SSI:s synpunkter på SKB:s redovisning av grundvattnets regionala flödesmönster och sammansättning, och deras betydelse för lokalisering av ett slutförvar

Review of: “On the role of mesh discretization and salinity for the occurrence of local flow cells” by Sven Follin and Urban Svensson (SKB R-03-23)

Clifford I. Voss
U.S. Geological Survey
6 July 2004

Review of “Grundvattnets regionala flödesmönster och sammansättning - betydelse för lokalisering av djupförvaret” (SKB R-03-01)

Figure 1 – 2D finite element mesh along east-west section through sites (entire mesh and close view of coastal portion) showing repository sites at 500m depth.

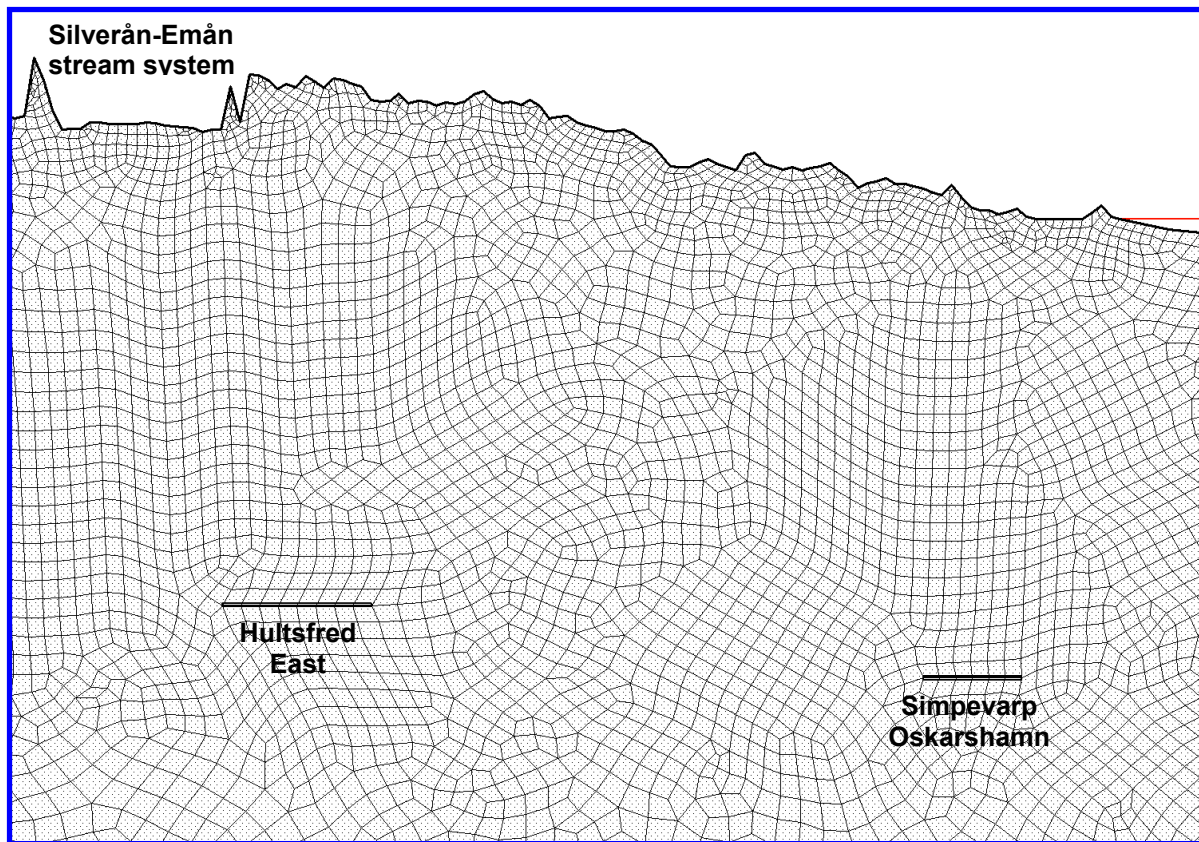
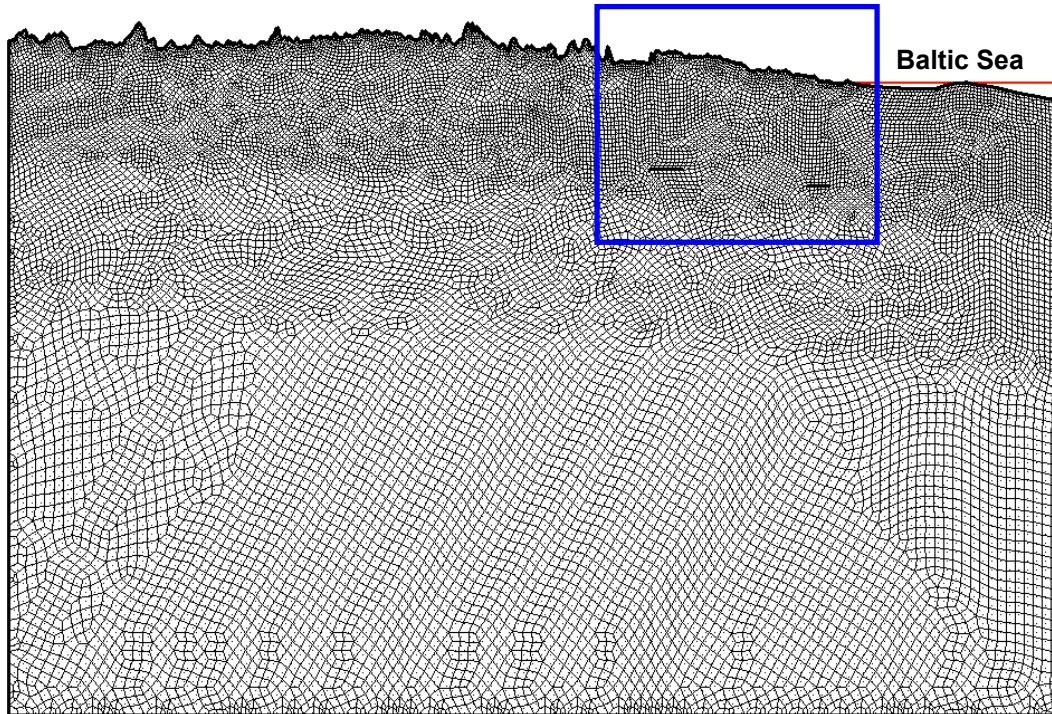
This reviewer made some cross-sectional analyses using a much finer mesh than that of FS using the 500m elevation data. Indeed, the vertical discretization in the cross section is significantly finer than both VP and FS. The objective was to carefully simulate all small shallow flow cells above repository depth. The cross section is along an east-west line that crosses the Hultsfred-east and coastal sites, close to the section shown in FS Figure 2.3 left. The region above the repository depth was vertically discretized into 30 to 40 elements in comparison with only 7 used by FS. Though the model was constant density, it only reached 3km depth, to roughly represent the influence of the brines acting as a barrier to deep freshwater flow cells. The model mesh, repository locations, and physiographic features are shown in **Figure 1**. Though the model is simplified, this reviewer believes that it gives roughly the same response as would a three-dimensional variable-density model.

Figure 2 – Return flow time (time before discharge for each point underground) (times given in years and are relative). Relative times in eastern part of East Hultsfred about 50000 years; times at coastal sites about 500 years.

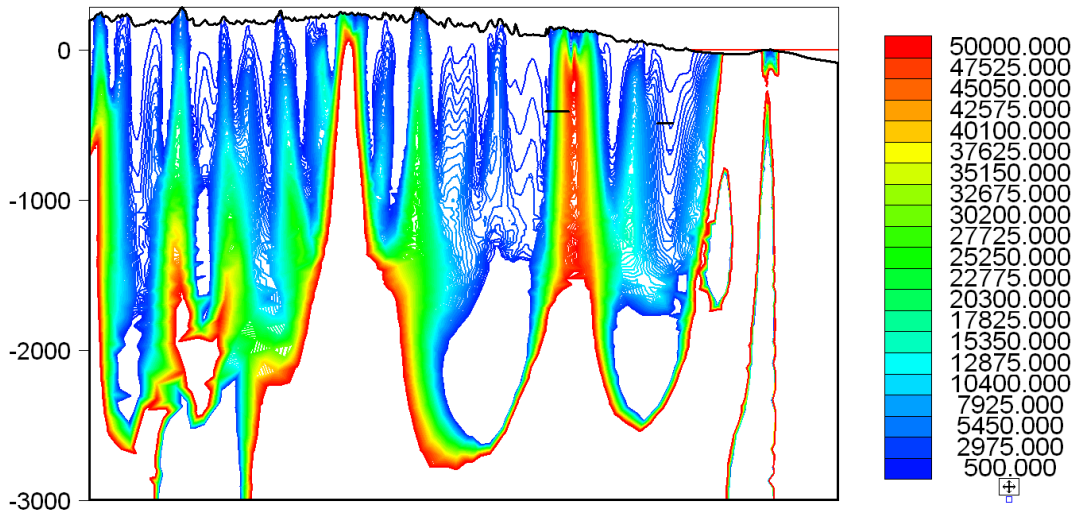
The results are similar to that found for VP for the Case 10:1. **Figure 2** shows that time of travel (return flow time) from repositories near the coast are several orders of magnitude lower than that from a repository in the eastern portion of the East Hultsfred site. Water recharged over the entire Hultsfred East site travels in two directions, the western recharge discharges to the Silverån-Emån stream system (**Figure 3**) and the eastern portion discharges to the Baltic Sea (**Figure 4-top**). Indeed, much of the eastern portion of Hultsfred East is a regional recharge area. This reviewer could not reproduce any shallow flow cells above this part of the Hultsfred repository; all flow is downward at repository depth. (Inspection of modeled velocity fields, not shown, confirms this.) The western portion of Hultsfred East is near a major stream valley and indeed, water passing through this region at repository depth discharges nearby in the Silverån-Emån stream system. This is in agreement with the statements of VP that it is the eastern portion of Hultsfred East that very long flow paths (~40 km) may be achieved. By placing the repository over the entire Hultsfred East site and not only the eastern portion, FS guaranteed that most of the discharge would be local - to the stream valley. In comparison, the plume from coastal repositories is shown in **Figure 4-bottom**.

Figure 5 – Comparison of steady-state plumes from repository located in eastern part of Hultsfred-East site and coastal sites for 1:1 bedrock permeability. (Concentration values are relative.)

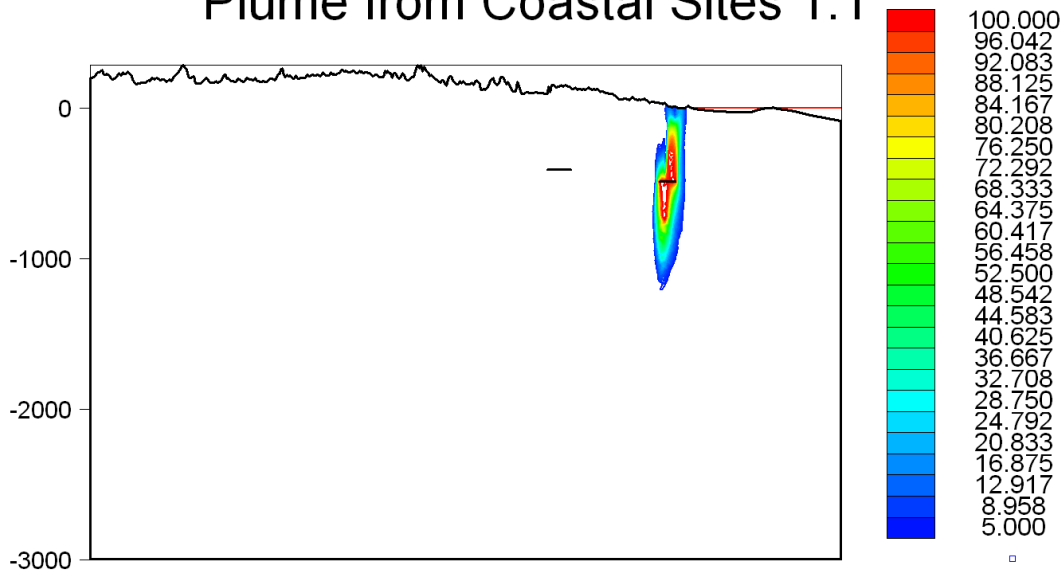
A second set of simulations by this reviewer was done for the only Case shown by FS, 1:1, isotropic bedrock permeability. Results for the 1:1 Case (**Figure 5**) indicate that some discharge areas from the eastern portion of East Hultsfred (**Figure 5-top**) may be closer to the release point than for the 10:1 Case. Despite this, for appropriate location of the repository within the eastern portion of Hultsfred-east, the shortest path length would still be long (~20 km to the closest major discharge point to the east, which is about halfway to the coast) with some radionuclides still reaching the Baltic on a deeper path. **Figure 5** also compares plumes from a Hultsfred and coastal repository for this bedrock representation. For both bedrock cases shown here, the inland repository has significantly longer discharge paths.
